Site Audit Report

Portion 1B and 1C, Sydney Metro West: The Bays Station, Rozelle, NSW

Final Report

Report Reference: 600199_0301-2206-2

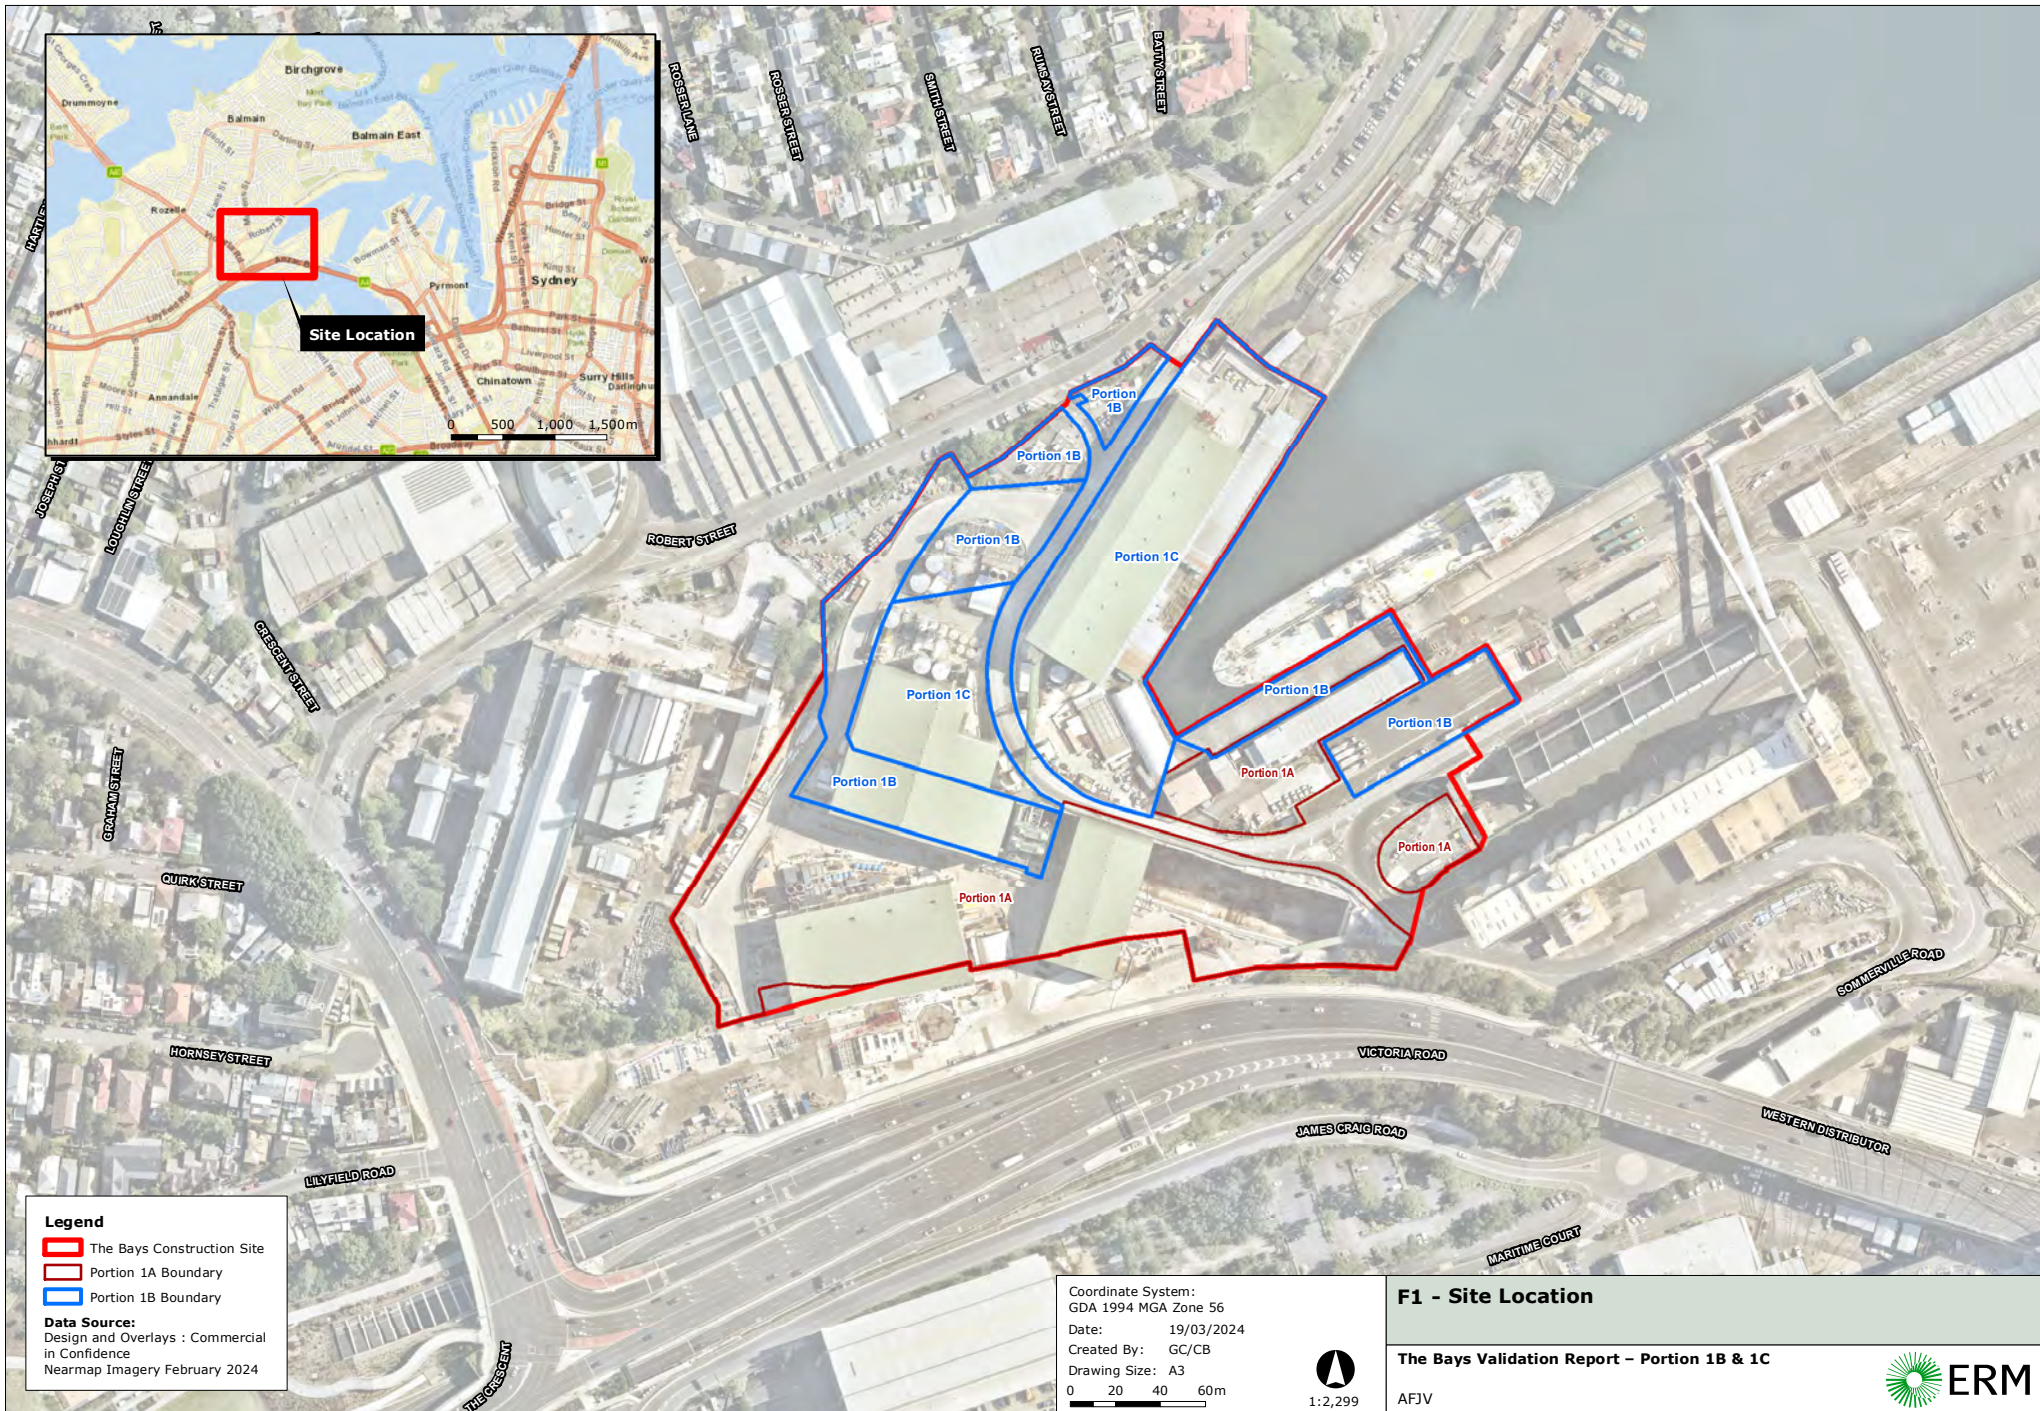
- 2) Figures
 - a) Figure F3. Review of the figures shows considerable portions of the site where no marker layer or capping was installed, and no existing cap was present. Please clarify the status of these portions of the site.

- b) Figure F5. The legend/key is blank.
 - c) Figures 6 and 7. Please clarify what the *Non-exclusive Use Areas* are and why they have not been included in the capping program.
